**PROPELLER SHAFT
AND UNIVERSAL
JOINTS**

CANCELS SERVICE BULLETIN NO.
CB-81. REF. SB/TJ.2/ET. 13.12.57.

PROPELLER SHAFT FRONT JOINT OIL SEAL UG.2995.

PROPELLOR SHAFT FRONT UNIVERSAL COUPLING

Fig. 1.

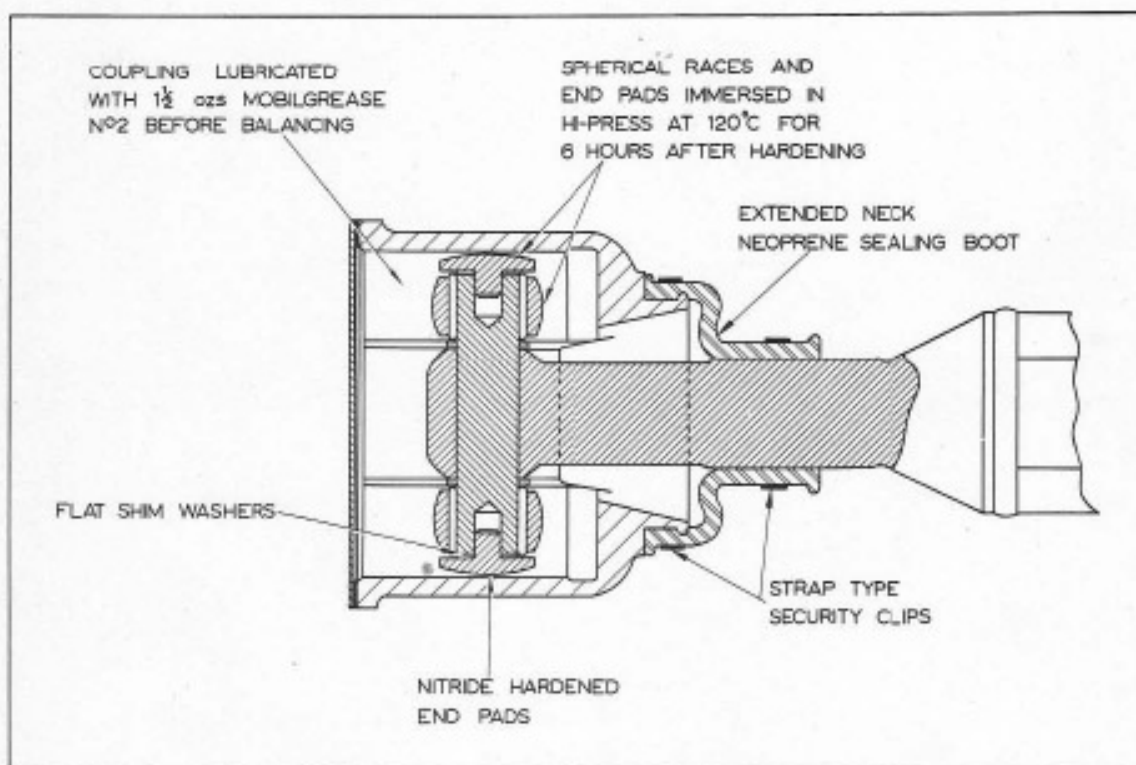
Fig. 1. shows at a glance the modifications incorporated on the front universal coupling used on 'S' Type cars in current production.

Early development work was, therefore, directed towards increasing the mechanical strength of the sealing boot. This was achieved by altering the elastomer specification from rubber to neoprene together with detail dimensional changes. The dimpled band security clips Part Nos. UG.1653/4 remain unchanged.

A redesigned sealing boot of non-Convolute form was produced to accommodate the change of lubricant and to ensure that it is confined within the outer lobes of the coupling body. An early alteration in the synthetic rubber specification of the redesigned boot to neoprene was found necessary to overcome initial manufacturing difficulties. At the same time, the dimpled band clip Part No. UG.1653 originally retained for use with this boot together with the reduced diameter dimpled band clip Part No. UG.3021, were superseded by 14 S. W. G. wire type security clips Part Nos. UG.3522/3.

The possibility of variation in dynamic balance occurring due to compression of the wavy washers fitted between the end pads and the cross-pin, has been countered by deleting the wavy washers and substituting flat shim washers. These are selected to give zero clearance of the cross-pin and end pads in the coupling lobes.

As an insurance against the boot being damaged in this manner, the clip has been repositioned further away from the seal face by extending the neck of the boot 0.575 ins. together with a corresponding increase in width of the sealing land on the shaft stem. The Part No. of this long neck sealing boot is UG. 3553, and it is permissible to use this latest seal as a service replacement when overhauling shaft assemblies originally fitted with the short neck sealing boot.
